BHARAT HEAVY ELECTRICALS LIMITED
PROJECT ENGINEERING MANAGEMENT, NOIDA

CORRIGENDUM- 02

PROJECT	:	2X660 MW UDANGUDI SUPERCRITICAL STPP ST
PACKAGE	:	D/G EOT CRANES ABOVE 100T
ENQUIRY NO	:	PE/PG/UDN/E-5994/2018 DTD 16/07/2018
SUBJECT	:	PRE- BID CLARIFICATION

PRE-BID CLARIFICATION SCHEDULE

TITLE CRANE CLEARANCE DIAGRAM OF TG HALL CRANE 200/40T (DOUBLE GIRDER) E.O.T. CRANE

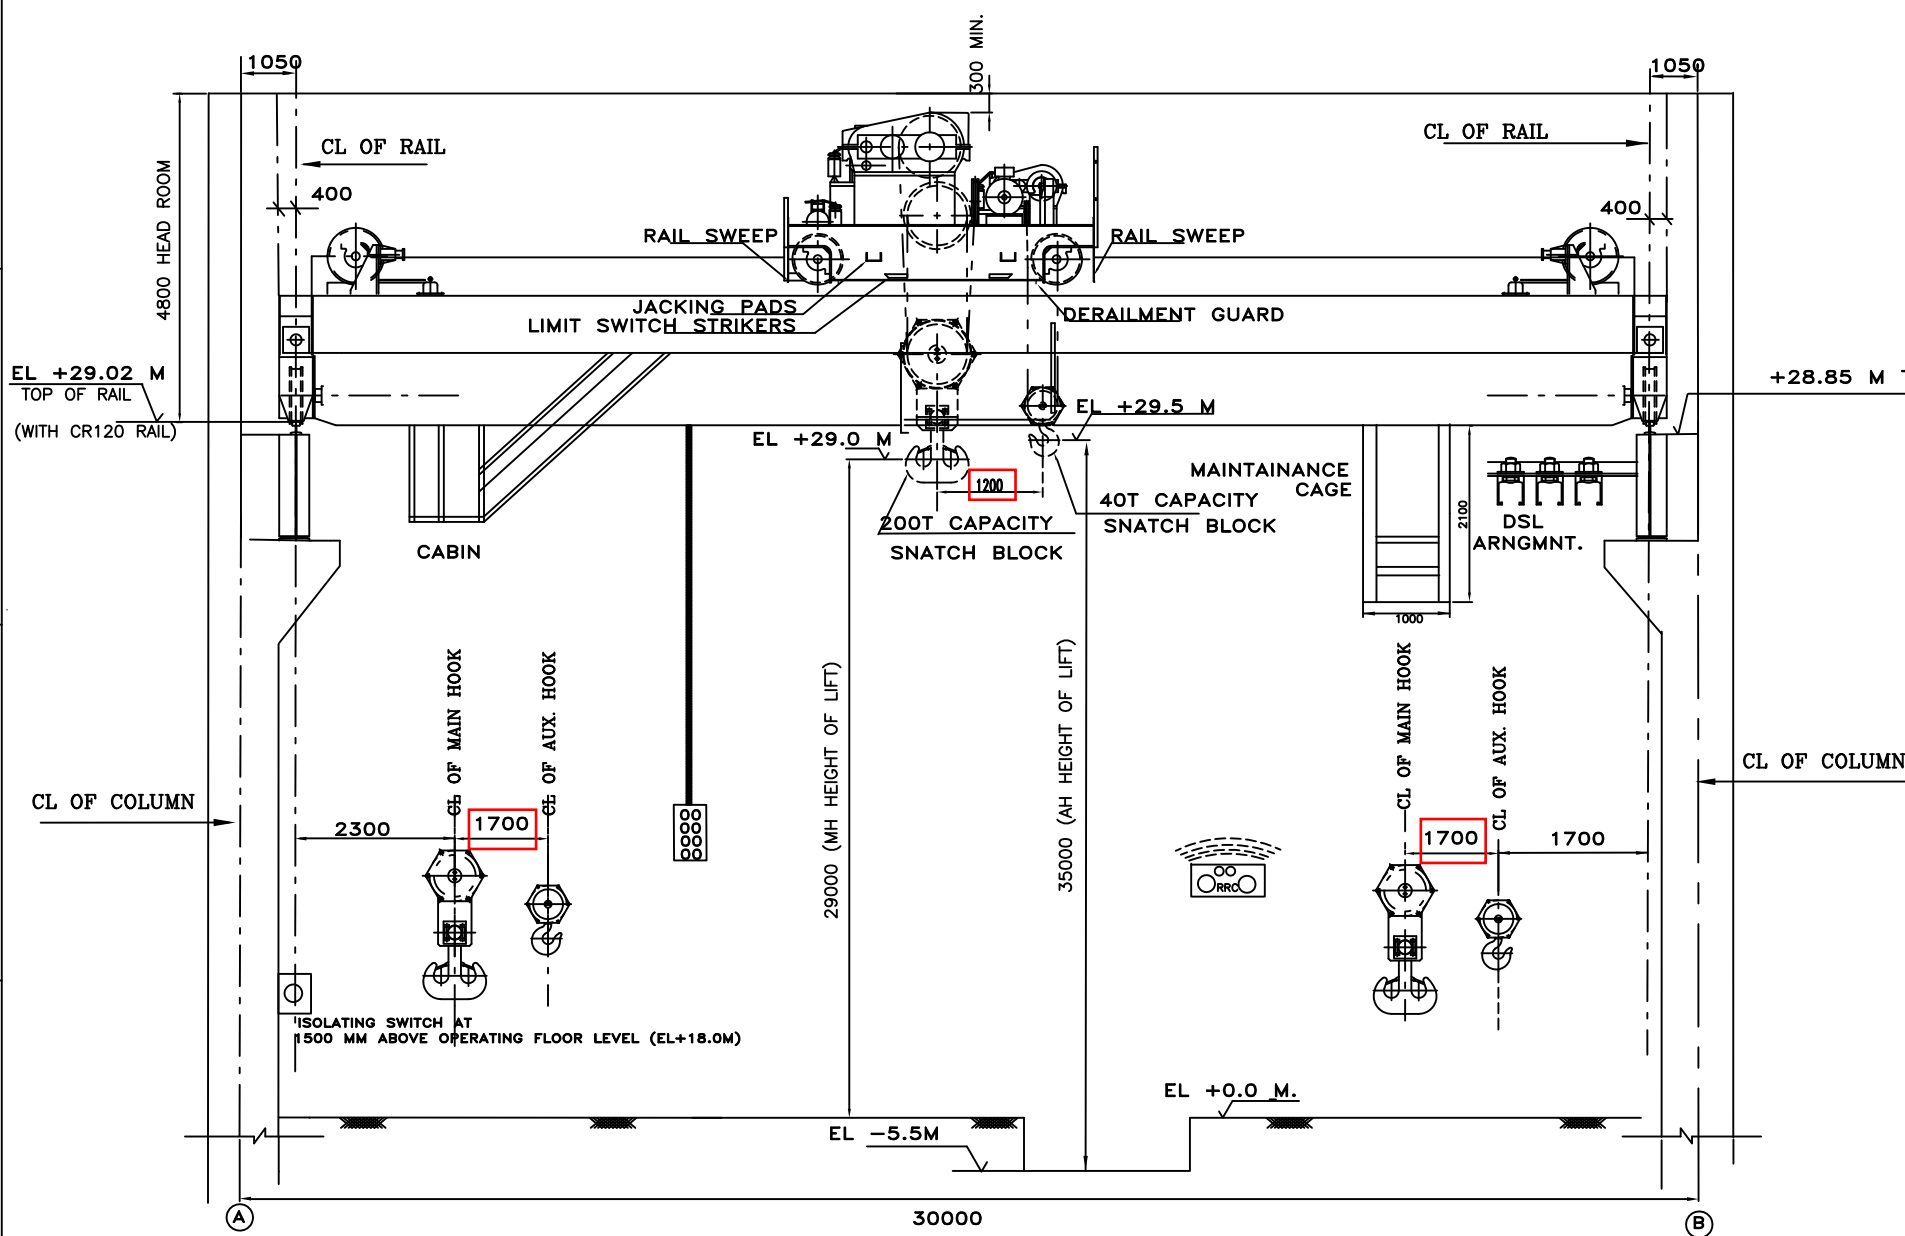
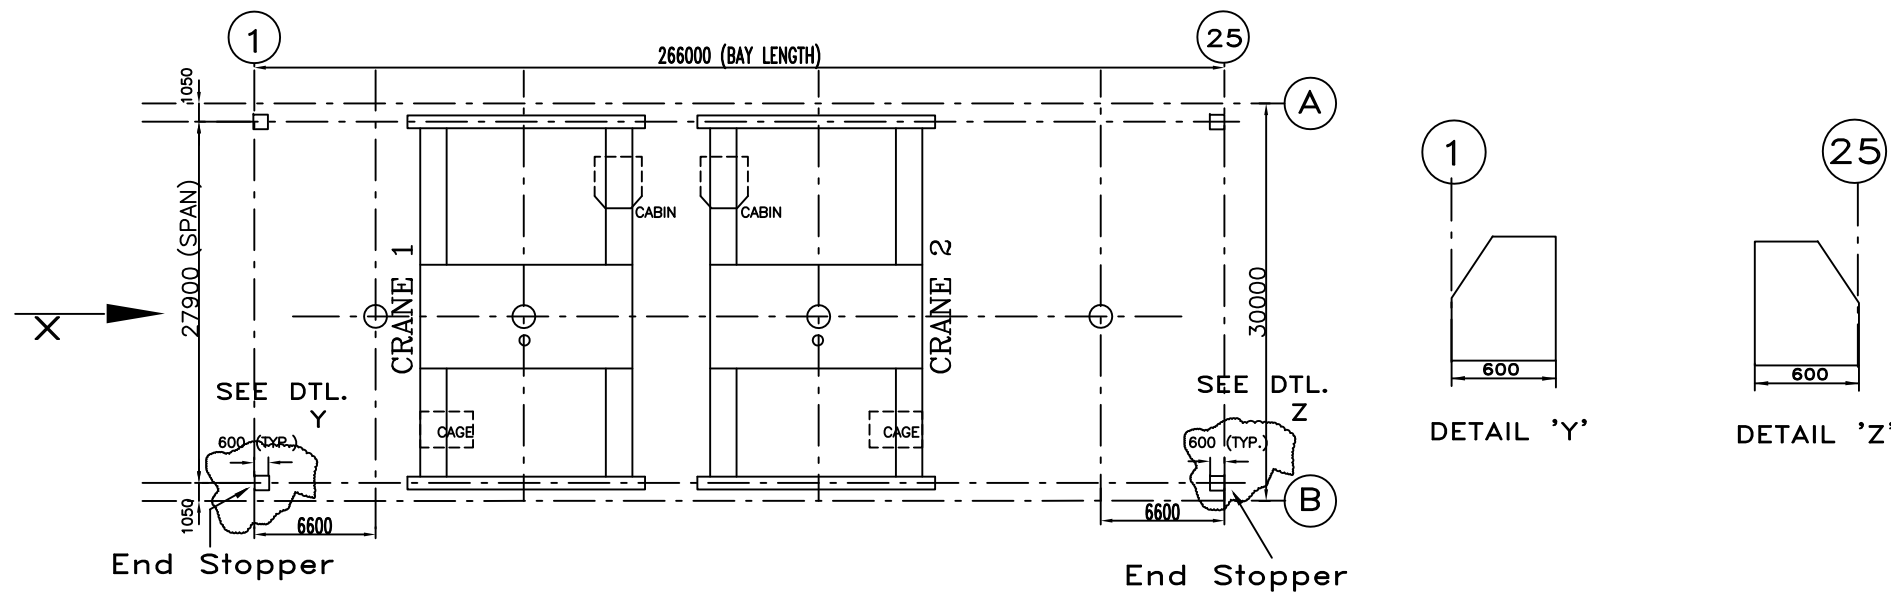
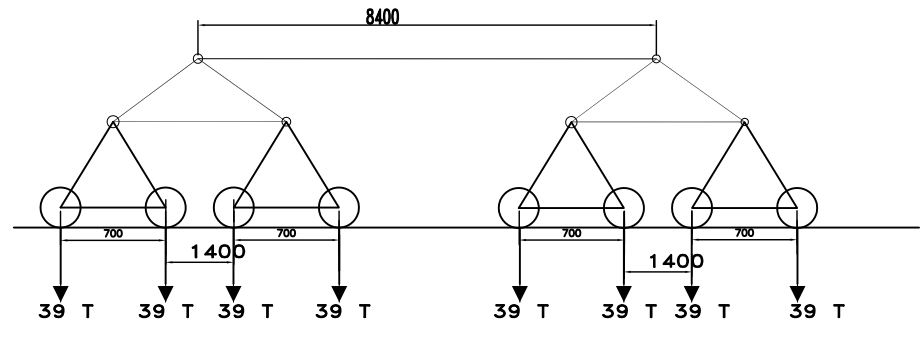
S. No.	Section/Clause /Page No.	Statement of the referred clause	Clarification Required
1	Crane Clearance diagram/72 of 191	Two Different value of distance between Main hoist hook & Aux. Hoist hook is shown as 1700 and 1200 in clearance drawing.	Please clarify which should be considered.

1. Distance between the main hook and aux. hook to be considered as 1700.
